RESPONSE TO NUCLEAR REGULATORY STAFF
REQUEST FOR ADDITIONAL INFORMATION ON
VIPRE/WRB-2 DNBR THERMAL LIMIT FOR
WESTINGHOUSE 17X17 OFA AND VANTAGE 5 FUEL

Document Number NFSR-0090 RAI Response #1

Nuclear Fuel Services Department
Commonwealth Edison Company
Chicago, Illinois

Figure 1: Measured-to-Predicted Critical Heat Flux vs. Local Mass Flux

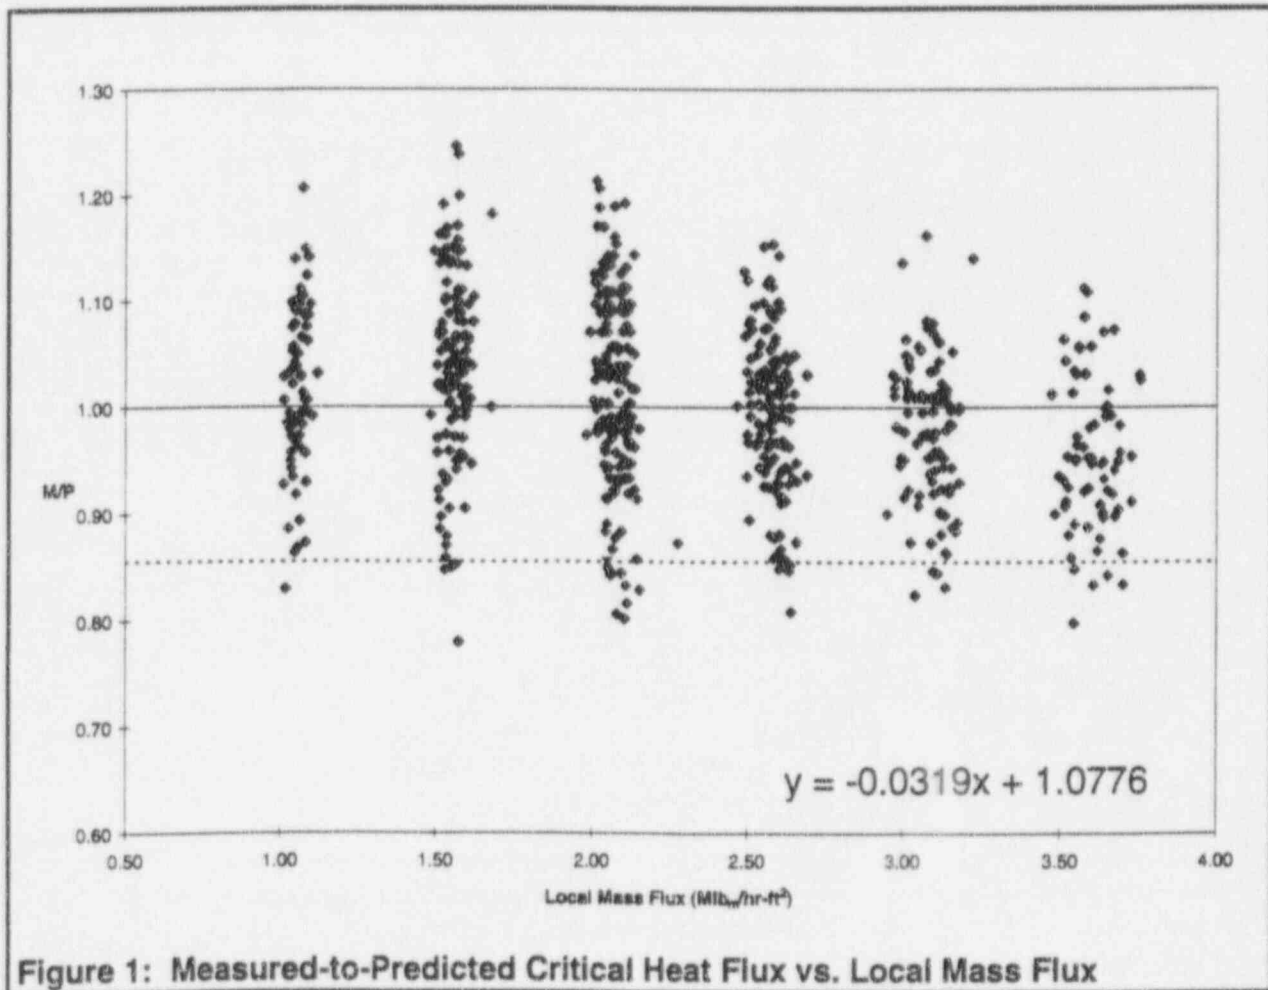
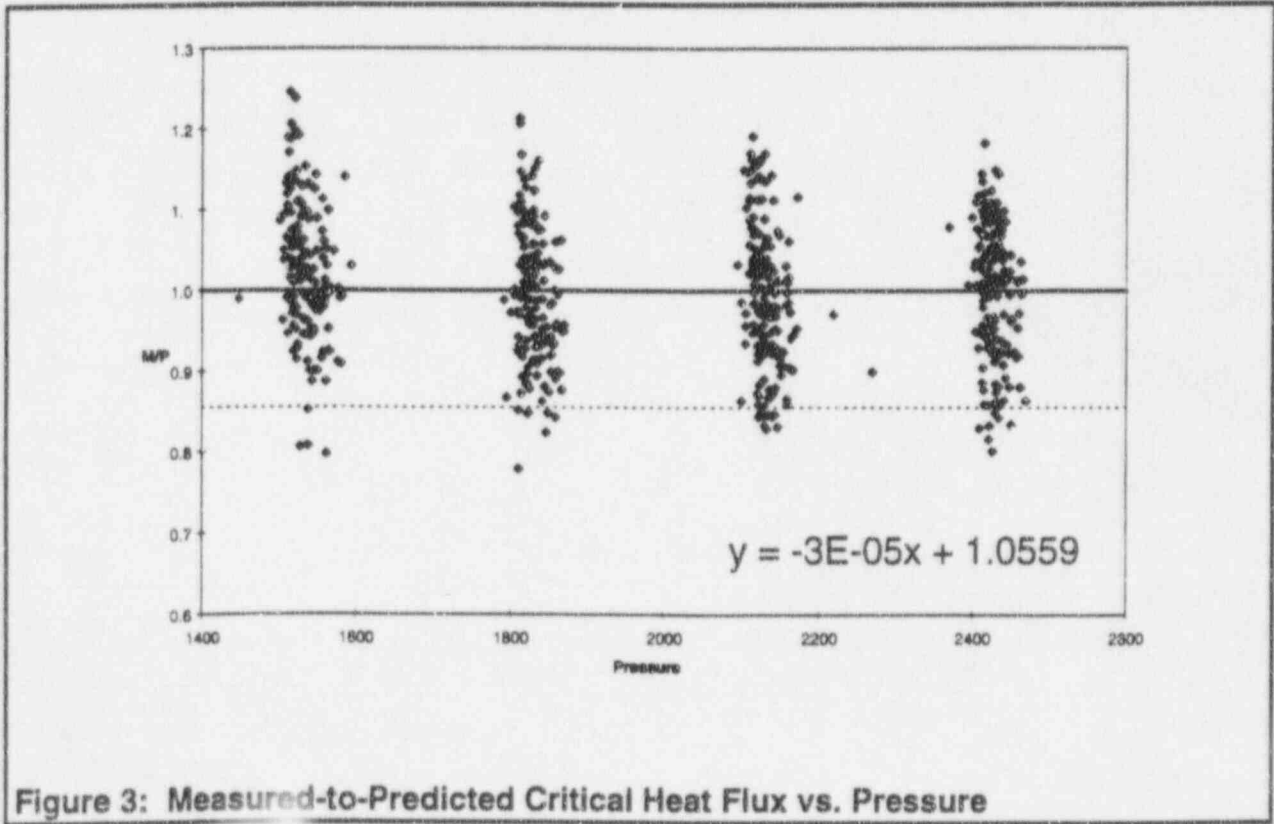
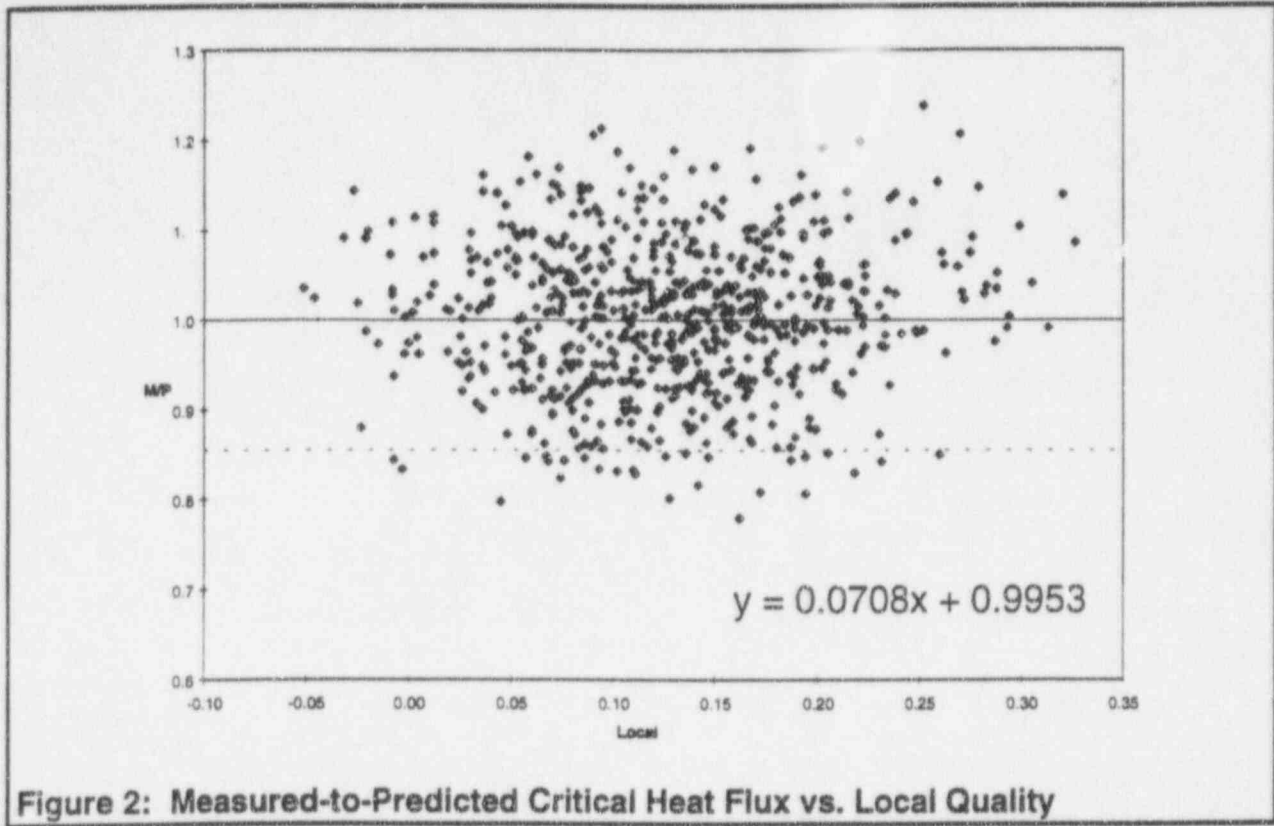
(Page 15) The figure on this page appears to show a consistent trend of the predicted CHF being conservative at low values of the local mass flux and non-conservative at high values of the mass flux. Please describe any analysis you have performed to quantify biases in the correlation. If no such analyses have been performed, justify that the apparent bias is acceptable by providing an upper bound on the bias.

Please provide the best linear fit of the data shown on page 15 as a linear function of mass flux. To determine whether there are other potential biases, please fit the data as a linear function of pressure and as a linear function of quality.

As addressed in the response to Question 5, ComEd also recognizes that there is a residual trend in the scatter plots. However, by comparing to Westinghouse's original submittal to the NRC (Reference 4), it is concluded that this residual trend is not a result of the implementation of the WRB-2 correlation in VIPRE. Any bias in the correlation will be bounded statistically by the 1.17 thermal limit; where the intent is that a calculated value of DNBR or 1.17 corresponds to 95% probability at a 95% confidence level of not experiencing DNB. Since DNBR is actually defined as the Predicted CHF/Measured CHF, the DNBR limit can be represented in terms of the Measured CHF/Predicted CHF value as $1/1.17$ or 0.855. The expected percentage of data points with a Measured CHF/Predicted CHF below 0.855 would therefore be approximately 5%. The 11 test series for the WRB-2 correlation contain a total of 684 data point. We would therefore expect fewer than 35 data points would have Measured CHF/Predicted CHF values less than 0.855. The actual data indicated 27 data points were below 0.855, which is less than the correlation infers, and is therefore conservative.

Figure 1: Measured-to-Predicted Critical Heat Flux vs. Local Mass Flux, Figure 2: Measured-to-Predicted Critical Heat Flux vs. Local Quality, and Figure 3: Measured-to-Predicted Critical Heat Flux vs. Pressure, which follow, include the equation of the best linear fit as requested. Also note the Measured CHF/Predicted CHF value of 0.855 corresponding to the thermal limit of 1.17 is indicated with a dotted line on these figures.

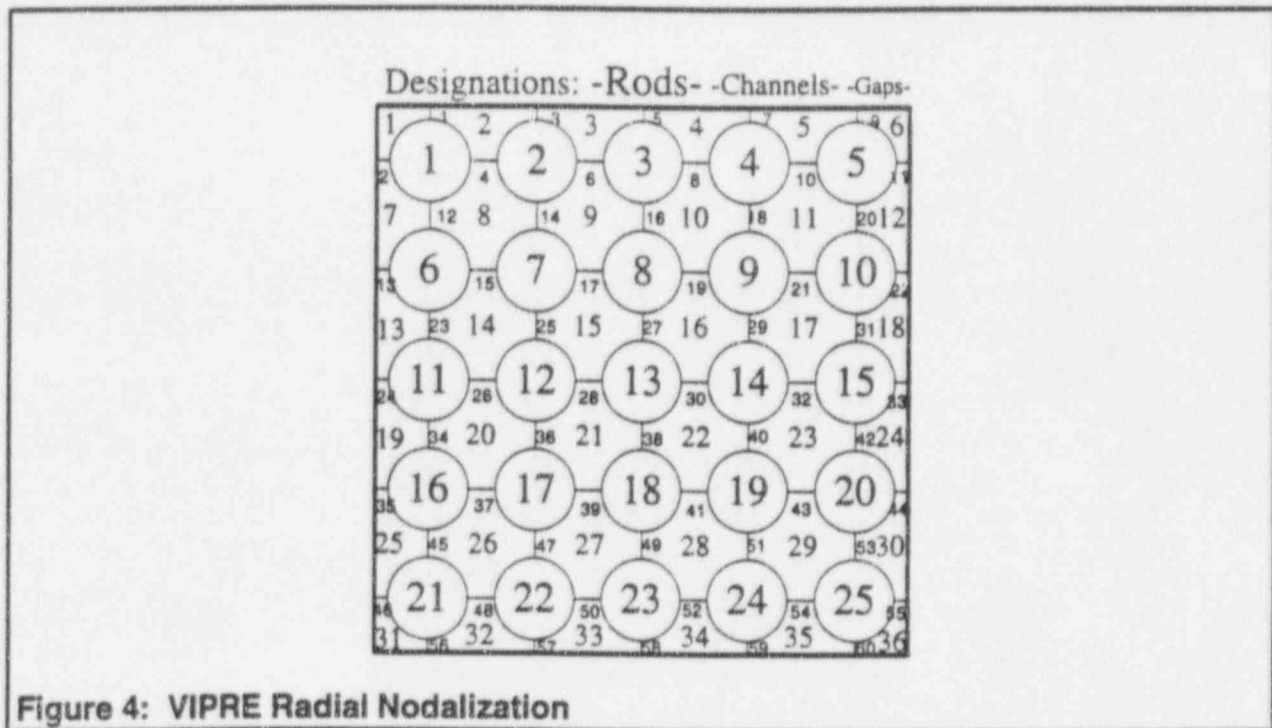
Tables A-1 through A-12 of the report provide only the predicted local heat flux and quality. Other parameters from the code simulations, such as local mass flux and heated length to the CHF position are necessary to make a prediction using the WRB-2 correlation. Please provide all applicable data that were used as input to the correlation.

Please note that there is no Table A-1 in Reference 2. The data included as Appendix A in our topical is listed by Westinghouse Test Section Number (Reference 4).

Appendix C contains the output listings of the VIPRE CHF summary files for tests A-2 through A-12. These output listings contain the following information:

- 1) Case ID Number
- 2) Operating Conditions
 - System Pressure (psia)
 - Inlet Enthalpy (BTU/lb_m)
 - Inlet Mass Flux (Mlb_m/hr-ft²)
 - Average Heat Rate (BTU/sec-ft)
- 3) MDNBR
- 4) Critical Location
 - Hot Channel Index (see Figure 4 on page 15)
 - Hot Rod Index (see Figure 4 on page 15)
 - Axial Level (in)
- 5) Hot Channel Conditions
 - Mass Flux (Mlb_m/hr-ft²)
 - Equilibrium Quality
 - Heat Flux (MBTU/hr-ft²)
- 6) Predicted Critical Heat Flux (MBTU/hr-ft²)
- 7) Correlation Flag (WRB-2 in all Cases)
- 8) Time (sec) (0.00 in all cases)

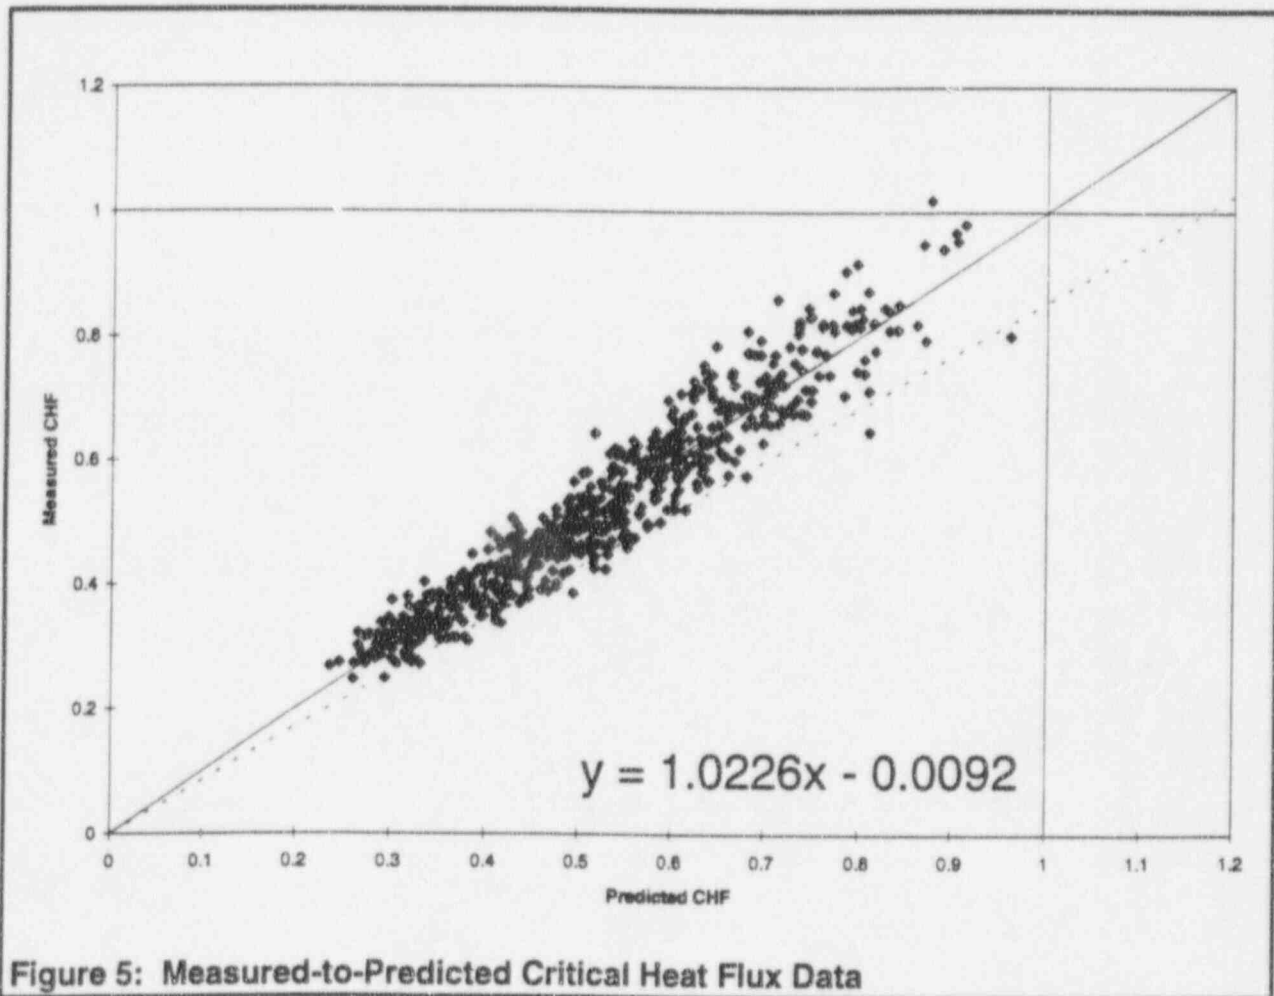
Please provide the radial layout of the VIPRE model of the test section tube bundle. For the data of Tables A-1 to A-12 identify which bundle subchannel is predicted to have the CHF and confirm that the local quality and mass flux values are for that channel? Do these "predicted" subchannels and rods match the experimental test data?

Figure 4 shows the radial nodalization of the VIPRE model used for the eleven (11) Westinghouse tests (A-2 through A-12). Again, please note that Reference 2 does not include a Table A-1.

Appendix C contains the VIPRE CHF Summary output file listings for each test series. These output listings include the location of CHF for each test along with fluid conditions at that location. ComEd does not have access to the measured subchannel and rod locations where CHF was observed. This information was not included in Reference 4. However, the VIPRE/WRB-2 predicted location of the subchannels and rods where CHF occurred were consistent with expectations. For the thimble channel tests, A-5, A-9, and A-11, the hot rod was always one of the 8 high powered rods (7, 8, 9, 12, 14, 17, 18, or 19) and the hot channel was one of the four channels associated with that rod. For the remaining cases, representative of a typical channel, the hot channel was always one of the four center channels (15, 16, 21, or 22) and the hot rod was one of the four rods associated with this channel.
